Final Drainage Report

**Eagle Rising
Filing No. 1**

Project No. 61145

PCD File No. SF2225

HEC-RAS Cross Section Location and Photo Key Map

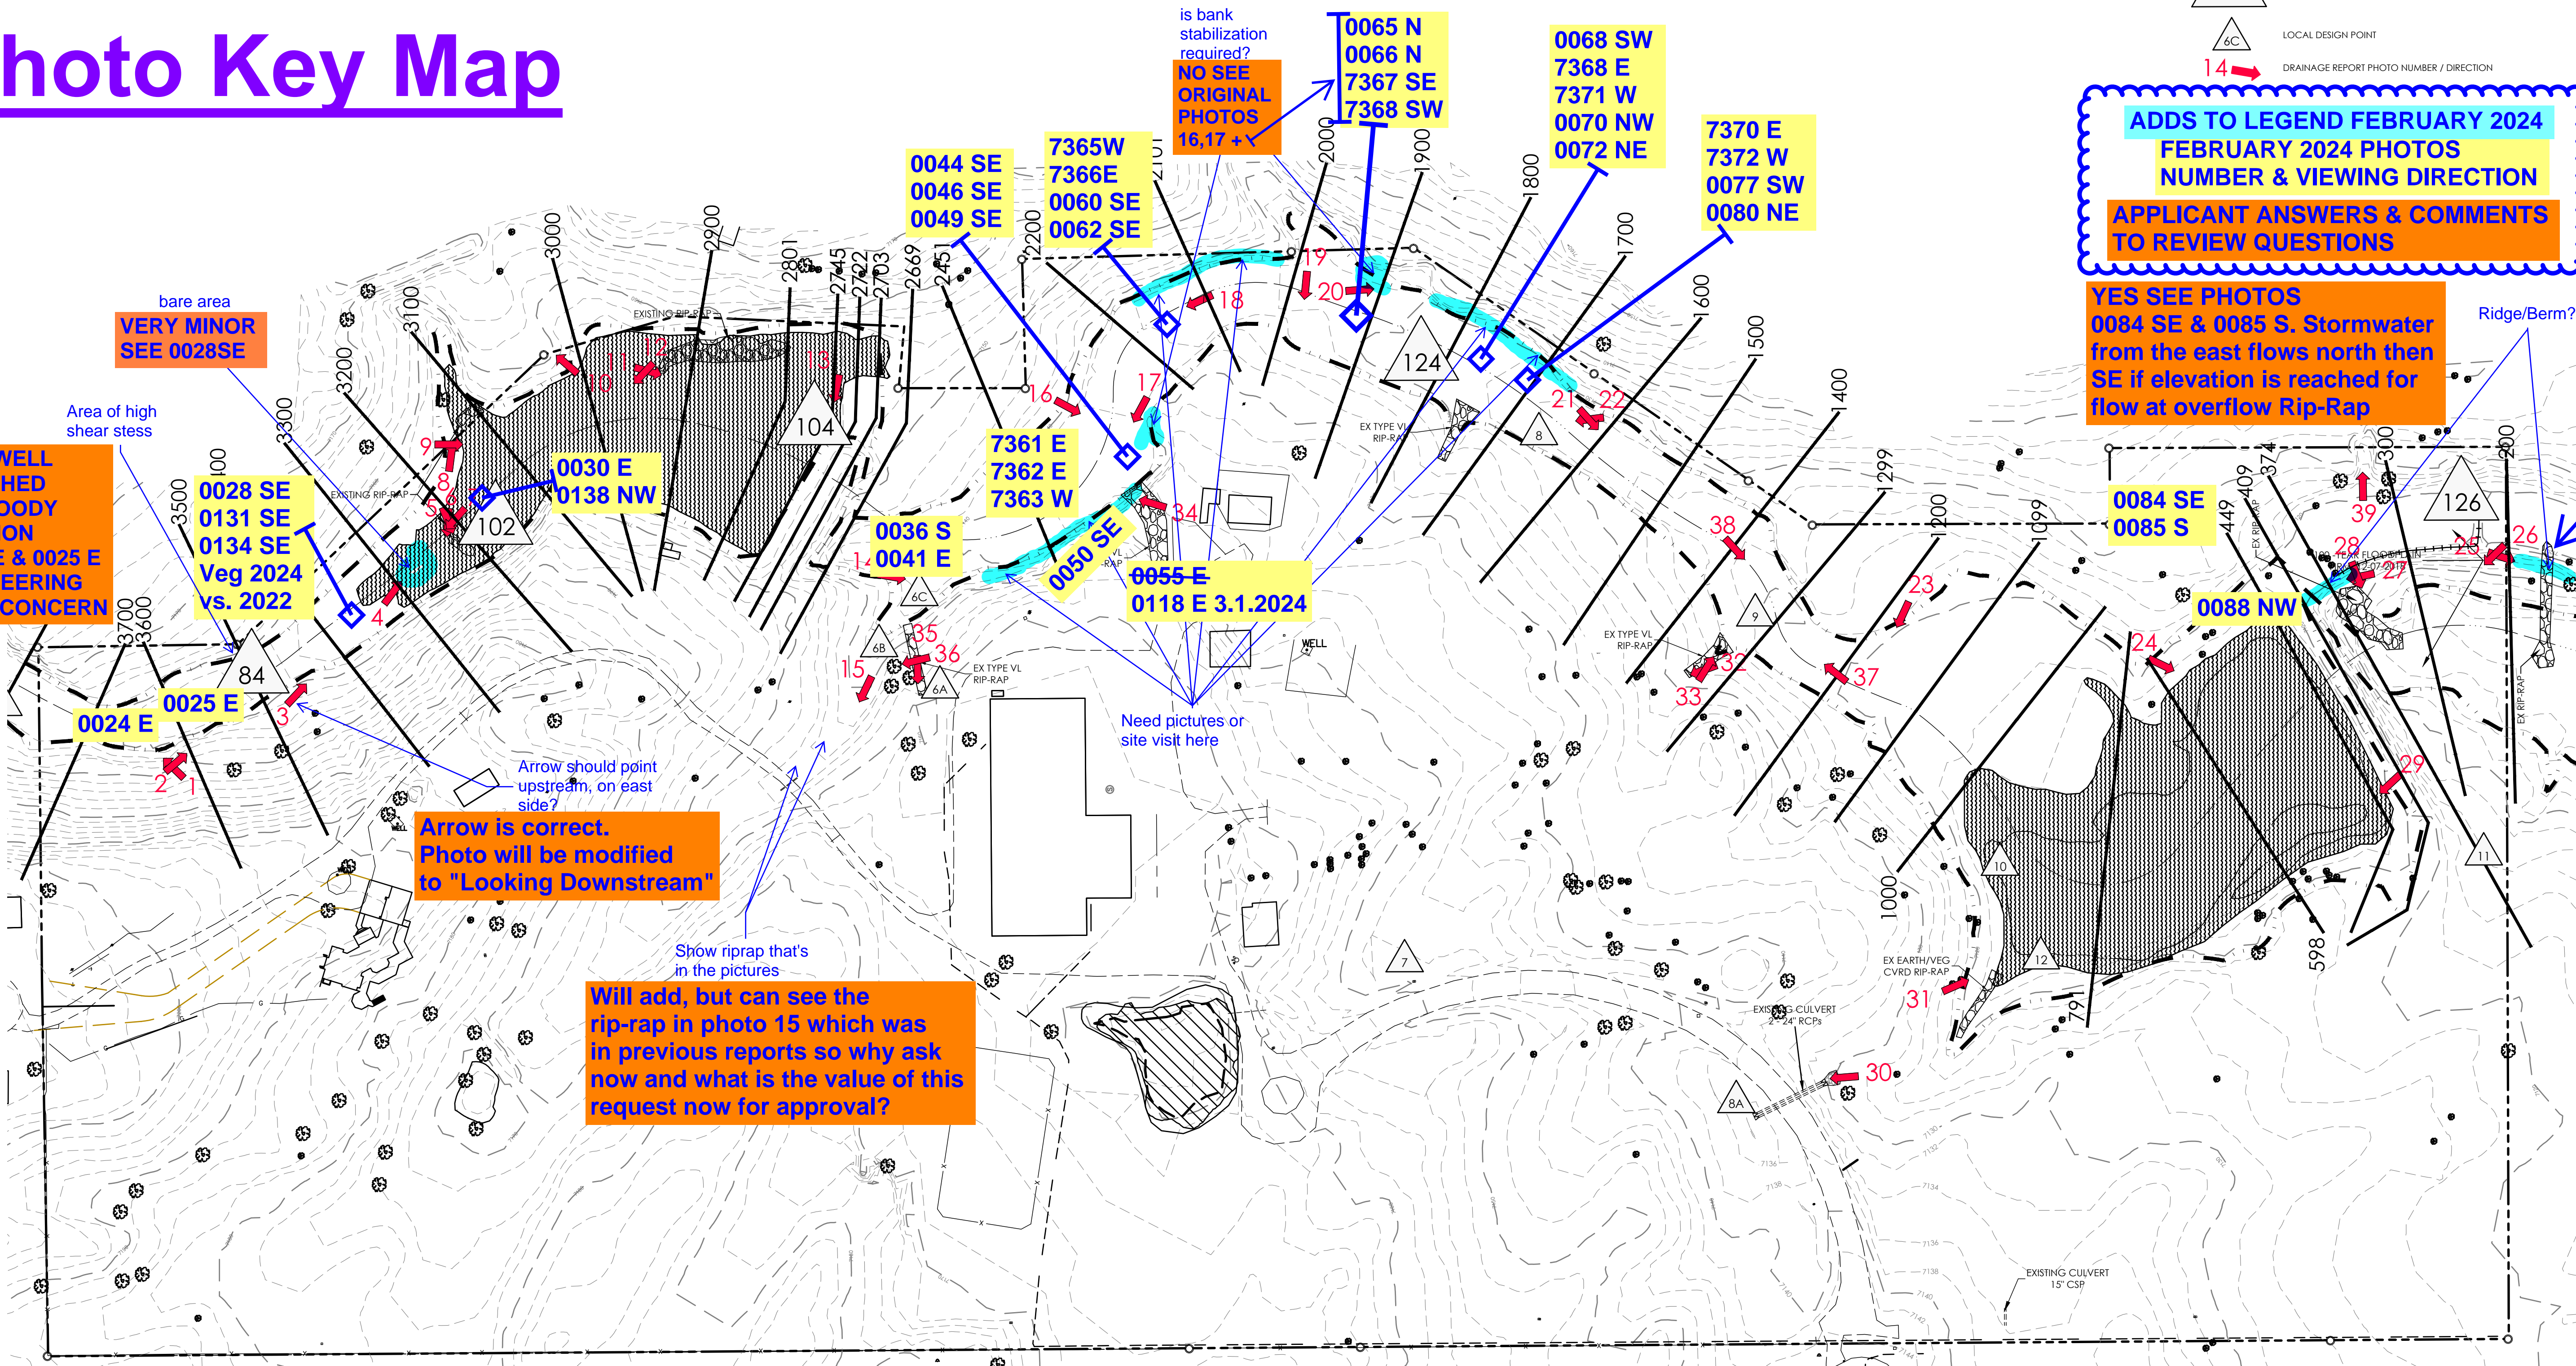
Show riprap that's in the pictures
Will add, but can see the rip-rap in photo 15 which was in previous reports so why ask now and what is the value of this request now for approval?

YES SEE PHOTOS
0084 SE & 0085 S. Stormwater
from the east flows north then
SE if elevation is reached for
flow at overflow Rip-Rap

CREEK ACCESS

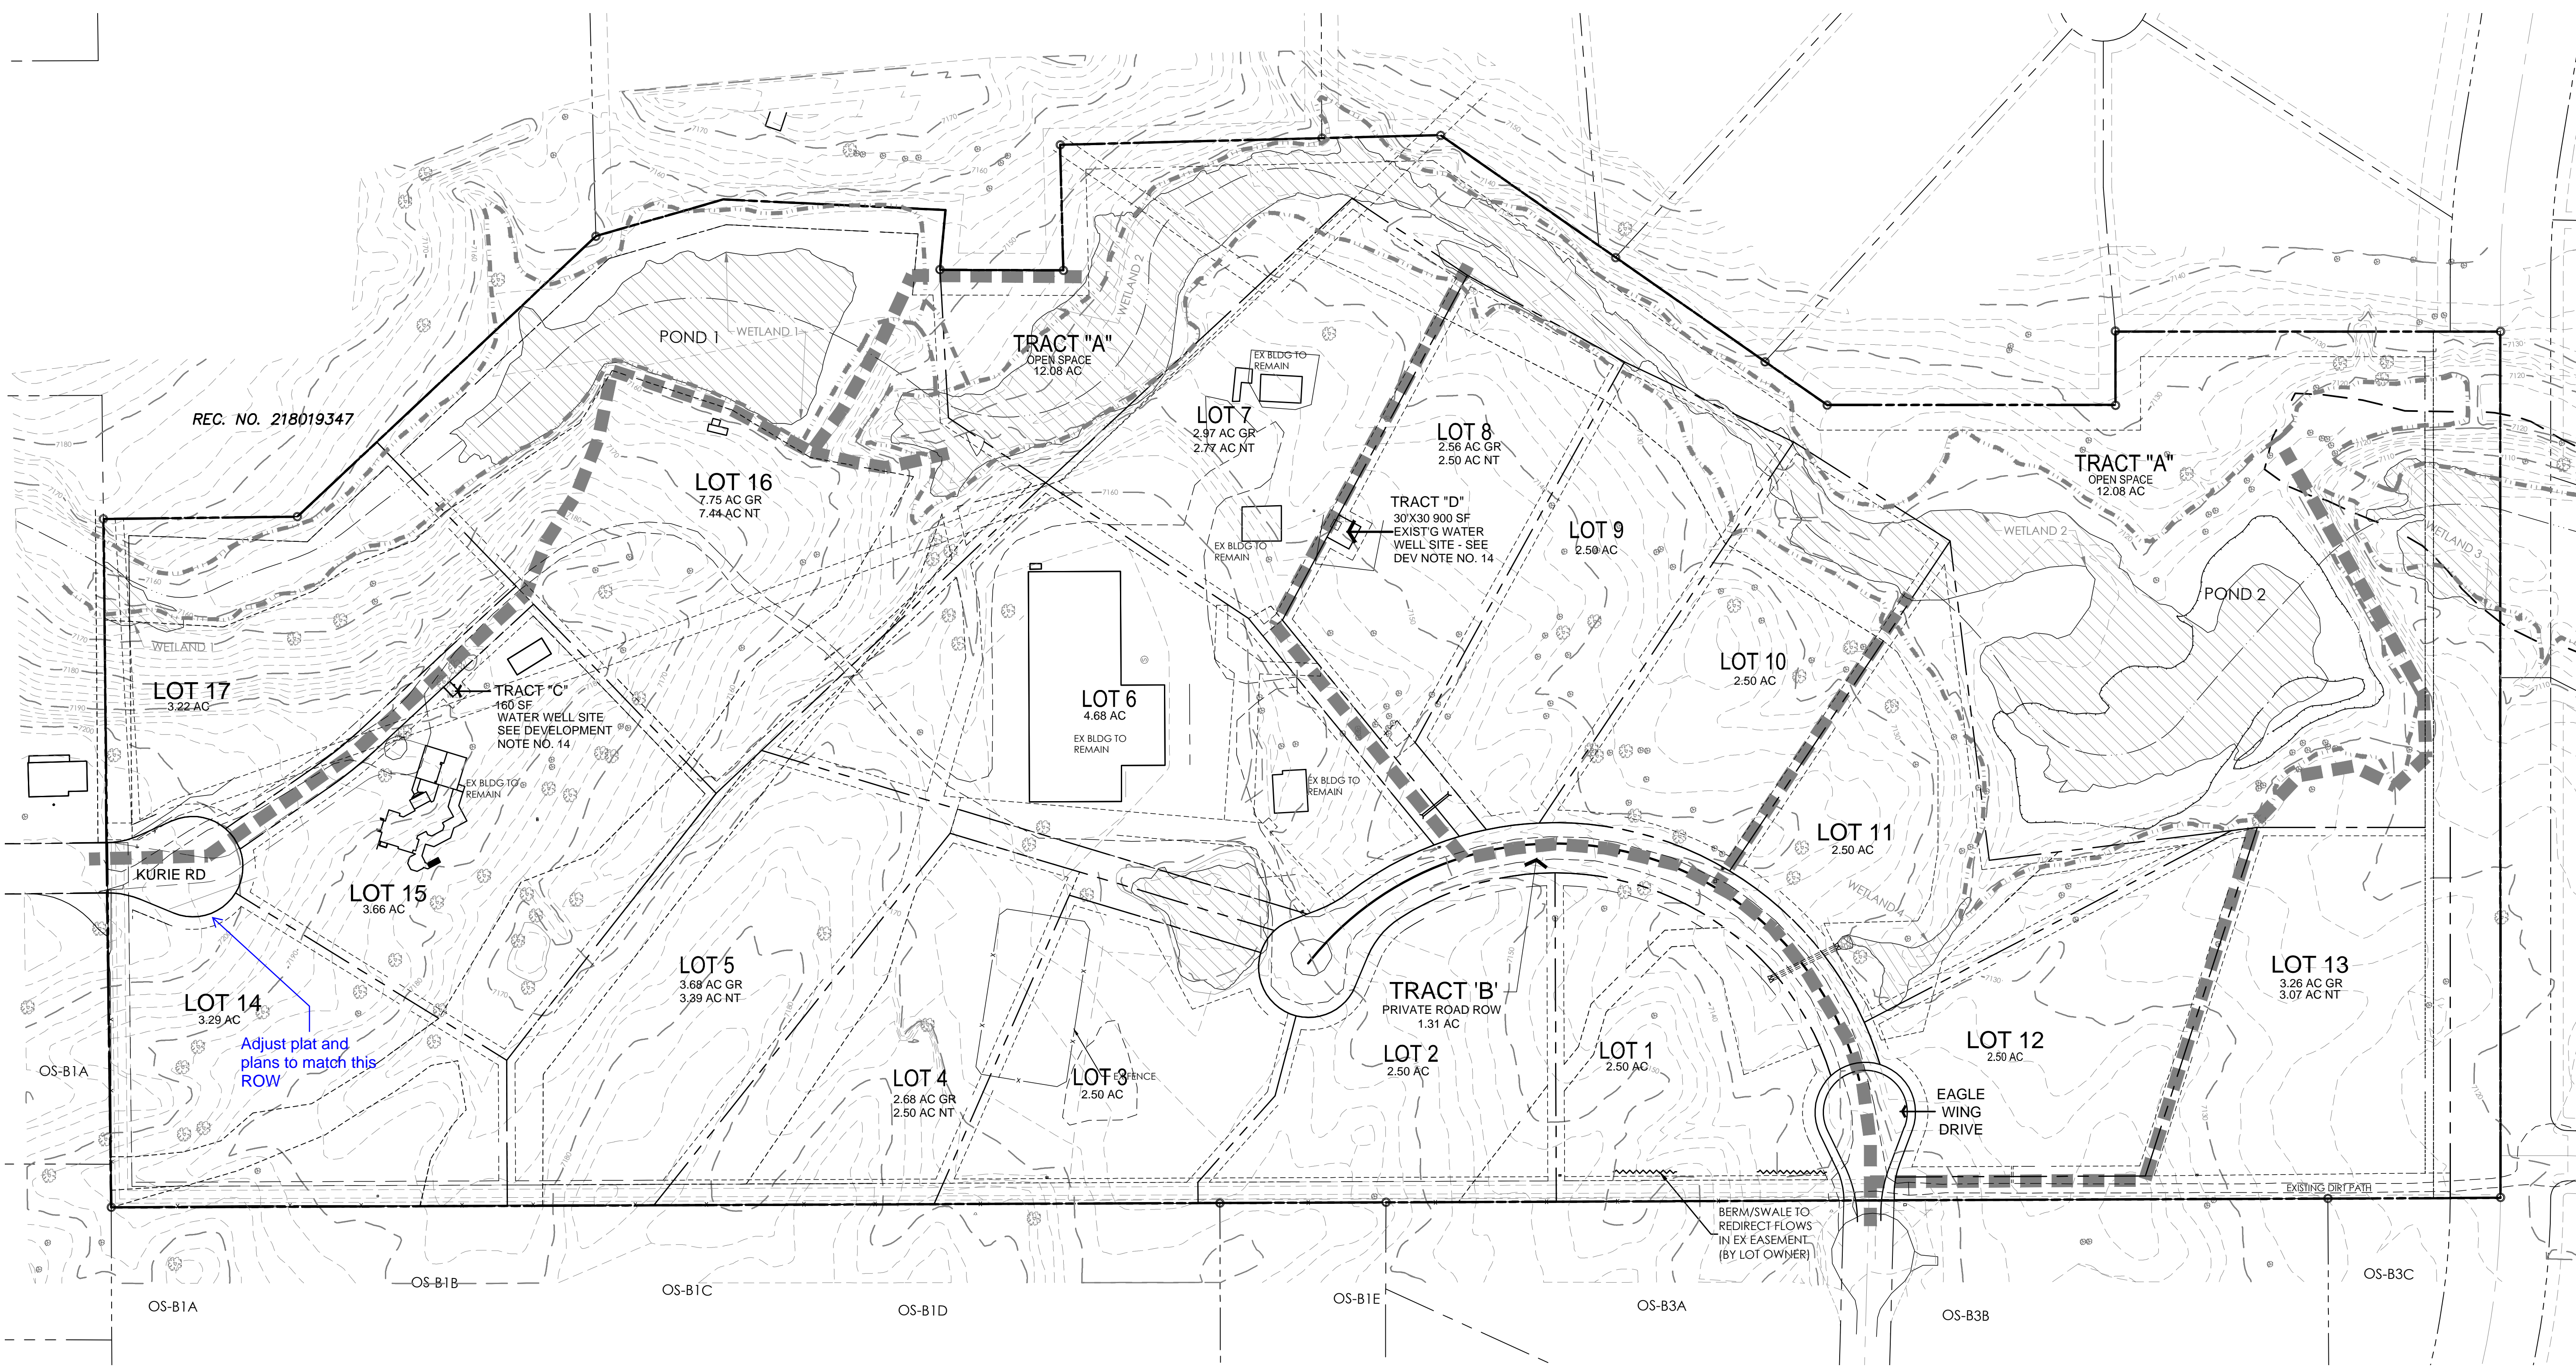
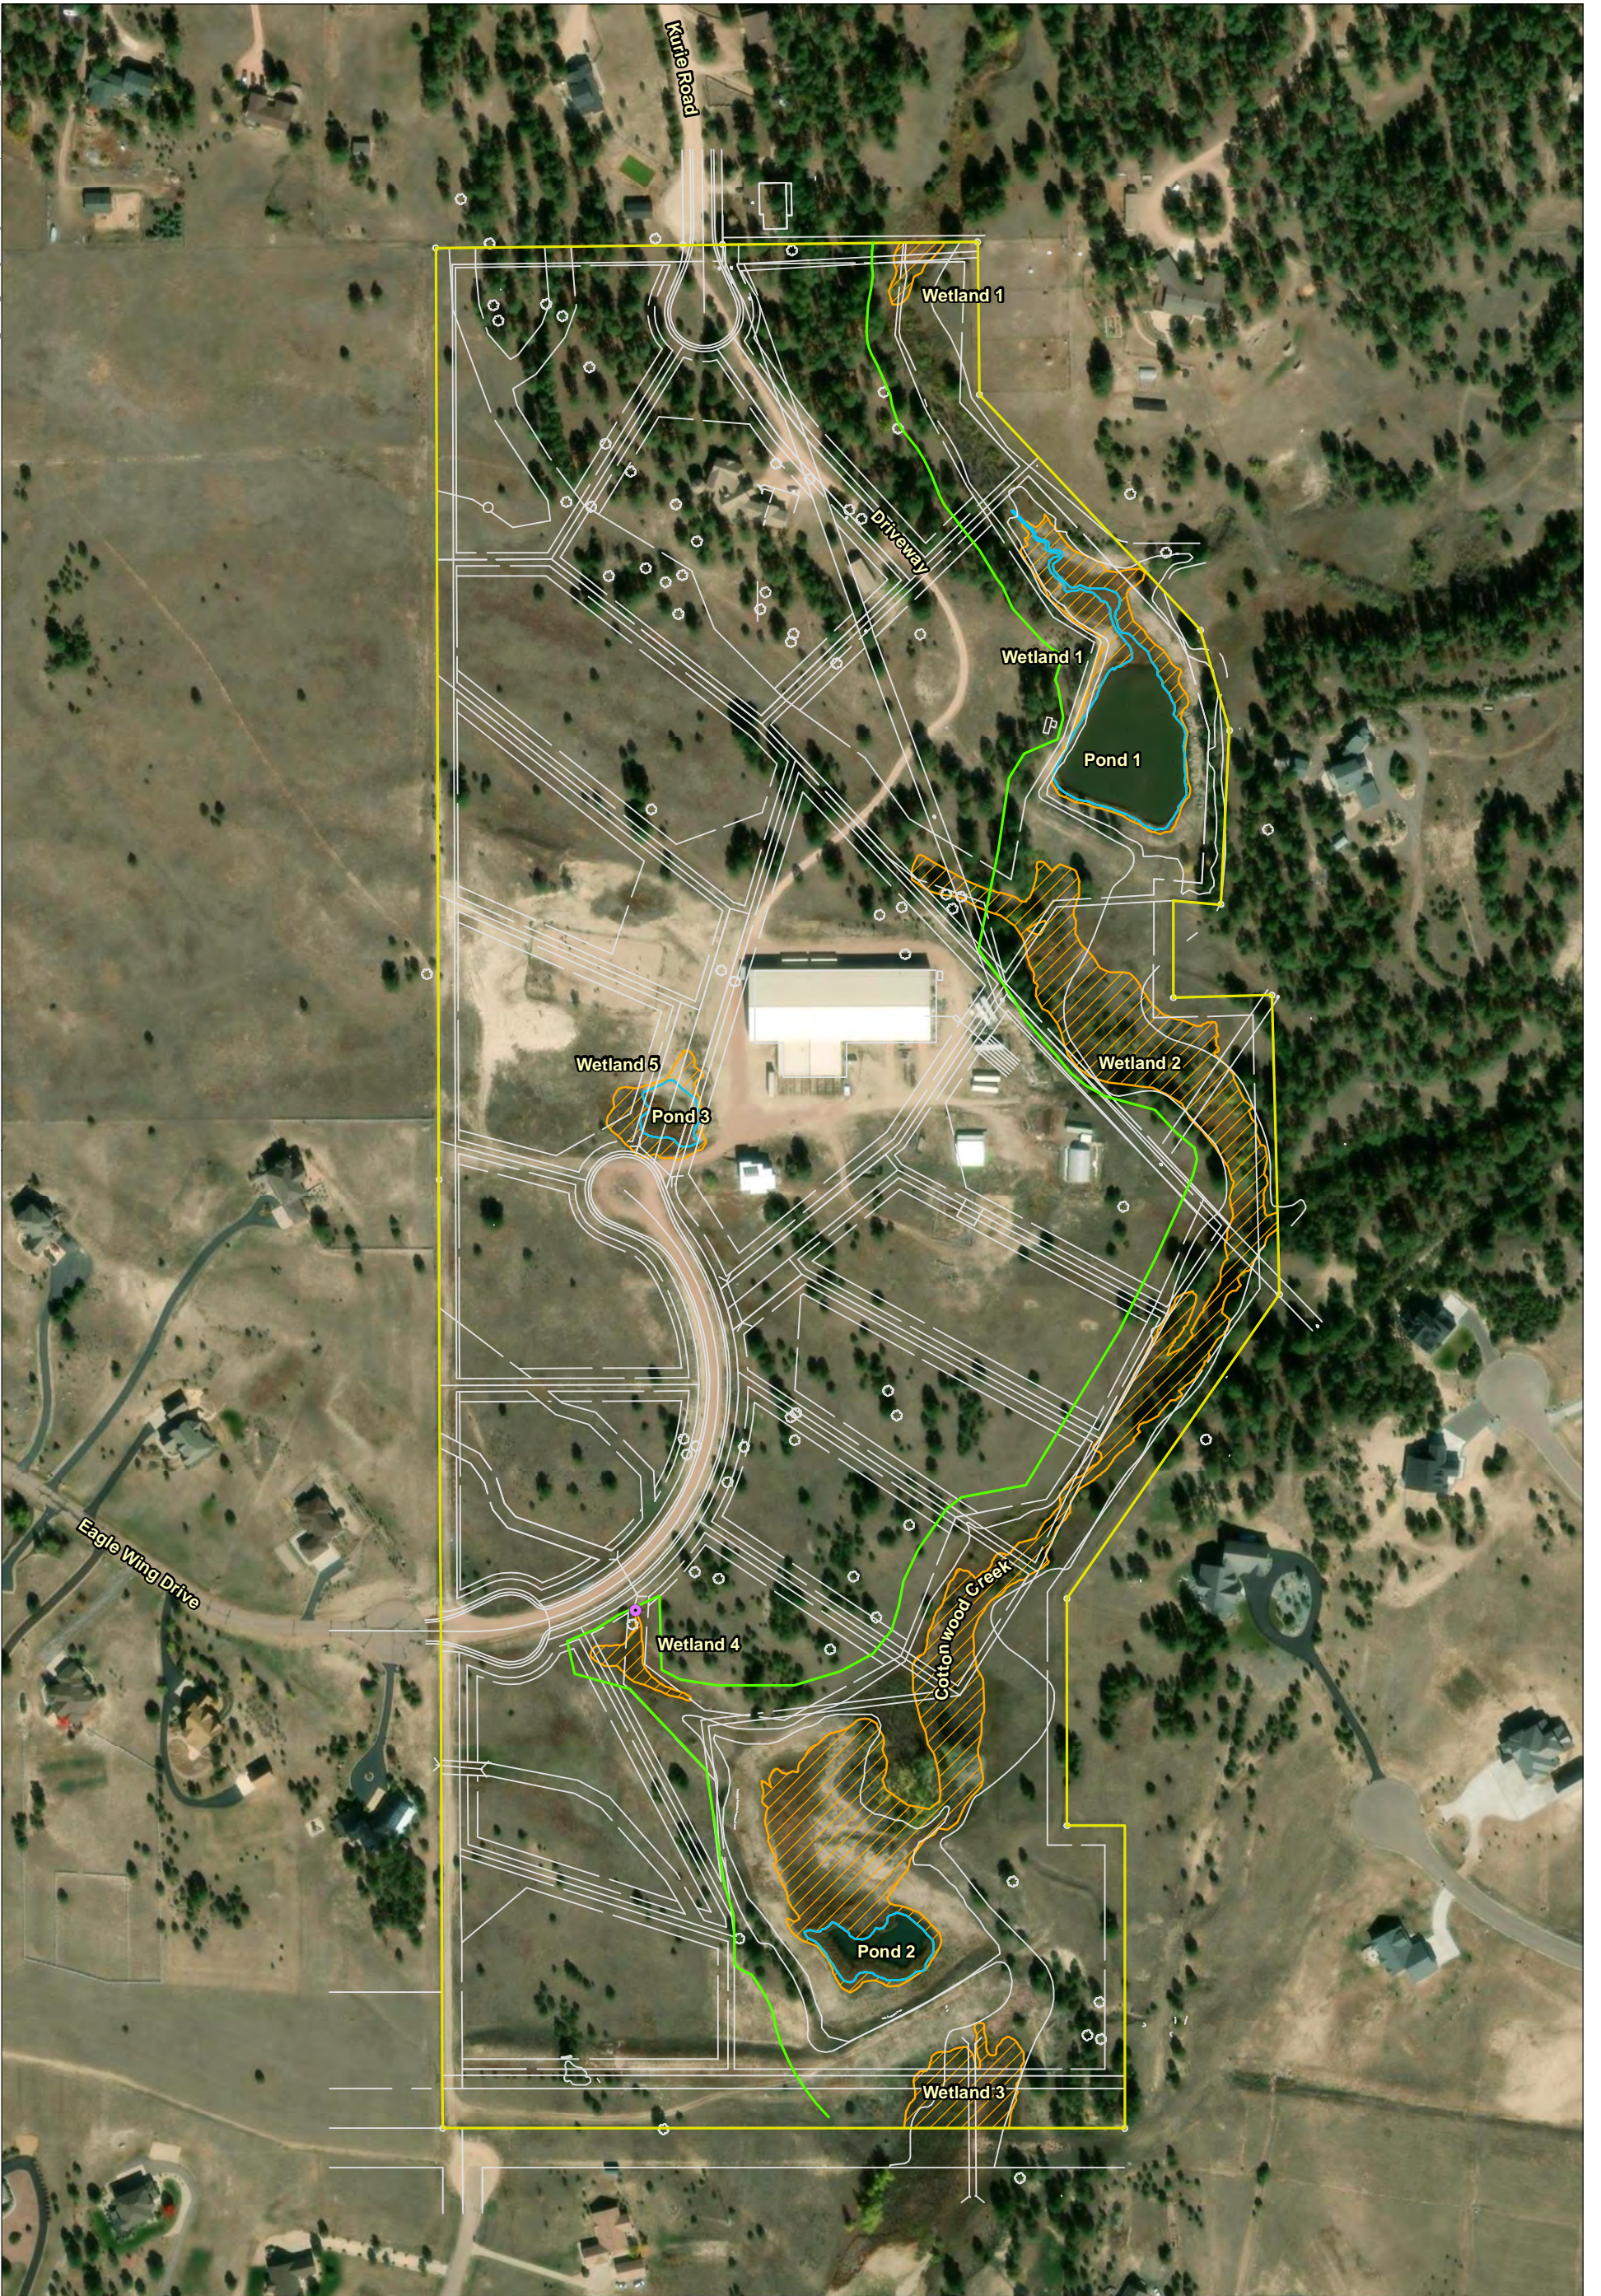
Delete "possible"

Unresolved: Label proposed widths and maximum grades on all access routes. (one note can be provided)
